Staff Report to the Zoning Administrator

Application Number: **121214**

Project Description: Proposal to recognize the construction of a deep pit stormwater percolation system approved under an Emergency Coastal Permit. Additionally, the proposal includes new construction of a 151-foot long shotcrete retaining wall, to a maximum height of 14 feet, to replace an existing wood retaining wall.

Subject: Review of Blufftop Retaining Wall Plans
630 Bayview Drive
Aptos, California
Santa Cruz County APN 043-152-16

**SITE PLAN—PROPOSED
BLUFF RETAINING SYSTEM**

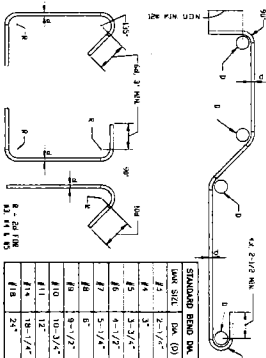
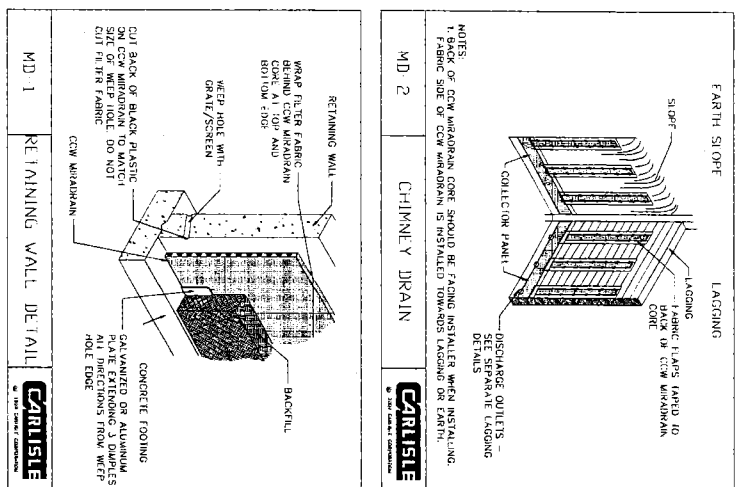
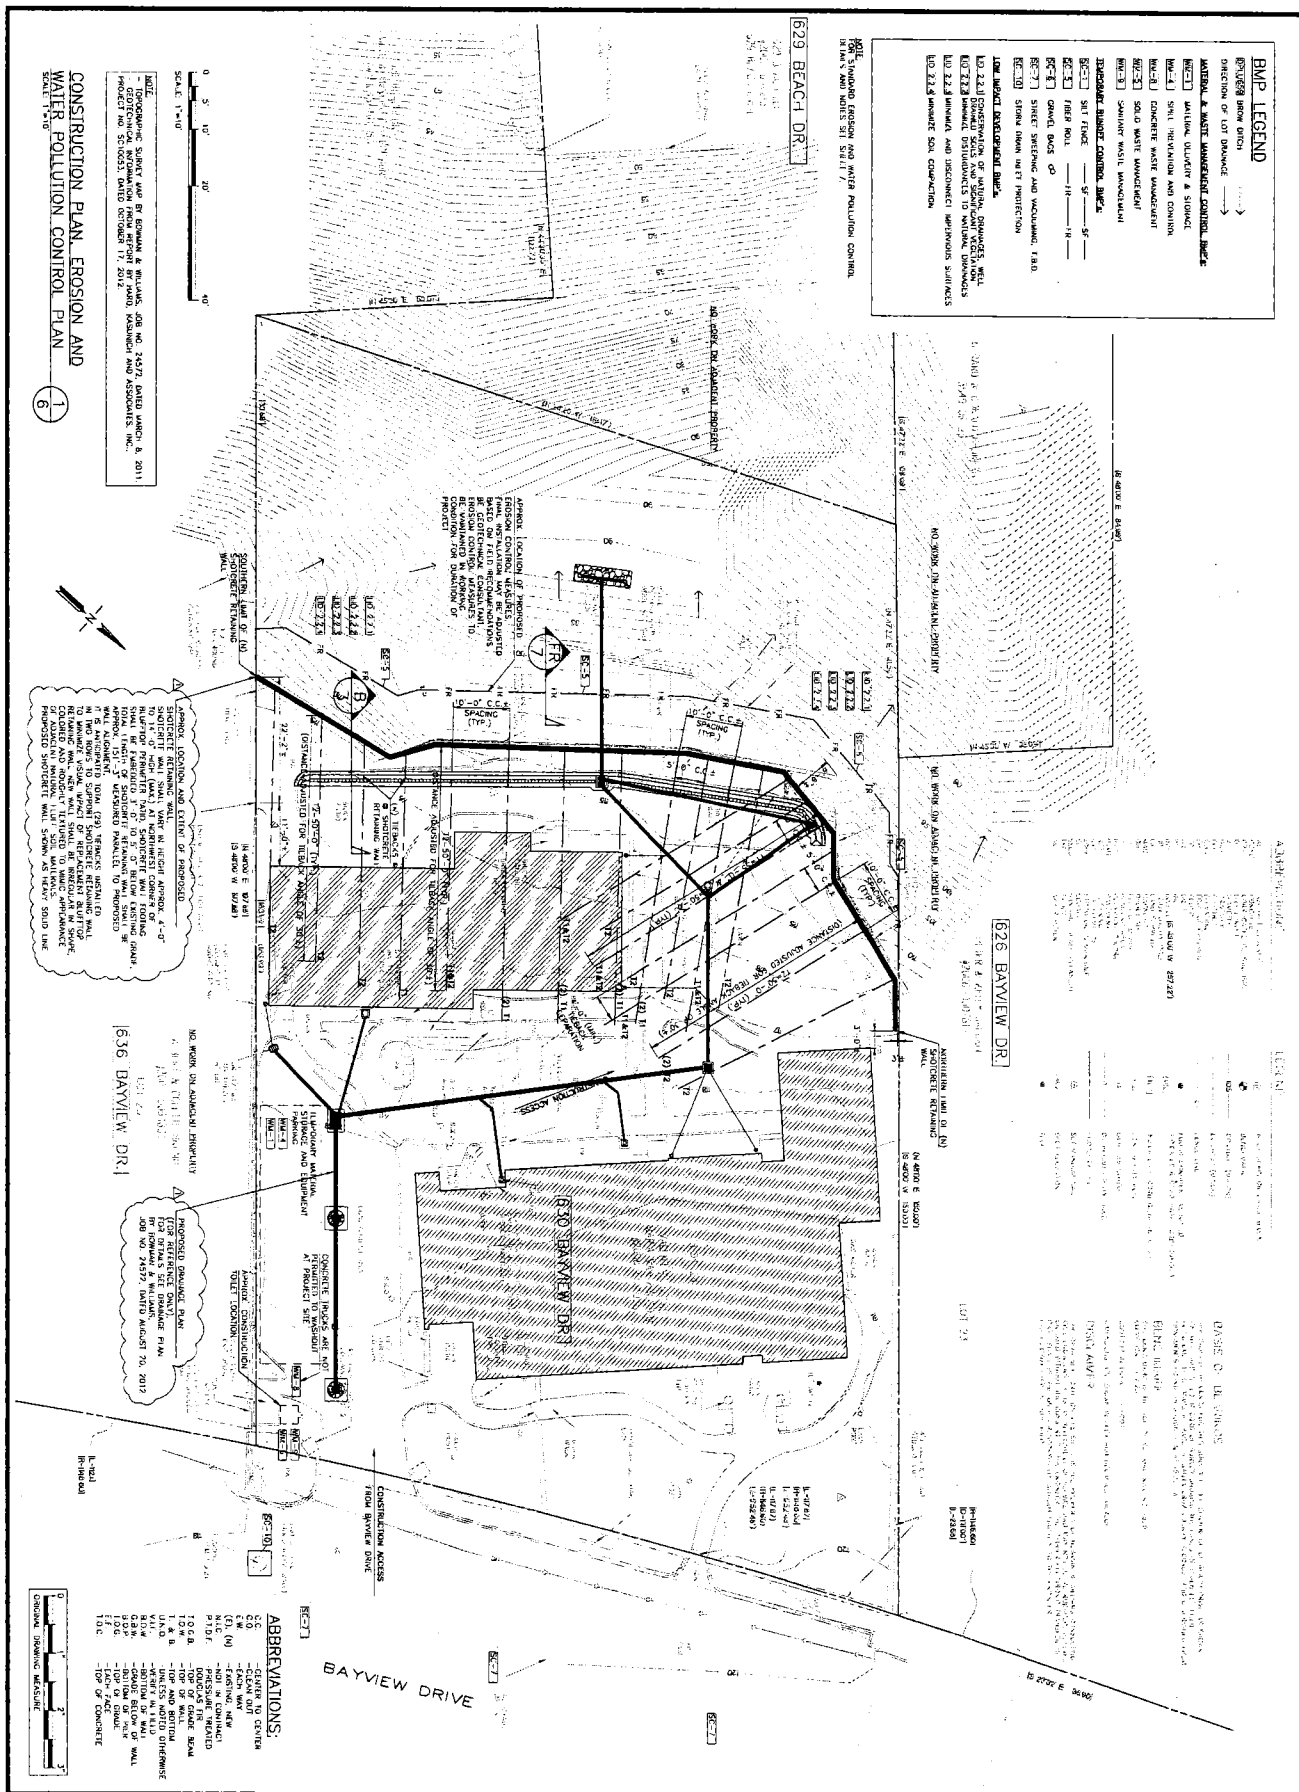
As requested, and as required by the Santa Cruz County Planning Department, we have reviewed the coastal bluff stabilization plans prepared by Soil Engineering Construction, the project structural engineers and contractor. The plans consist of seven Sheets, dated 12 March 2013, detailing a proposed tieback shotcrete retaining wall to replace a failing, aged wood wall. The proposed new wall will be constructed in essentially the same location as the existing wall.

As depicted on the plans, the proposed new tieback retaining wall will consist of a shotcreted, reinforced vertical wall retained by one or two rows of tiebacks. The base of the wall will be embedded a minimum of three feet into native earth materials and penetrate below a 1.5:1 line projected from the base of the slope.

The blufftop stabilization plan is in general conformance with the recommendations of our geologic report (REJA, 2011).

During construction of the wall and drainage improvements, a representative from our firm should inspect wall excavations and the exposed earth materials, as well as to identify any unexpected adverse geologic conditions.
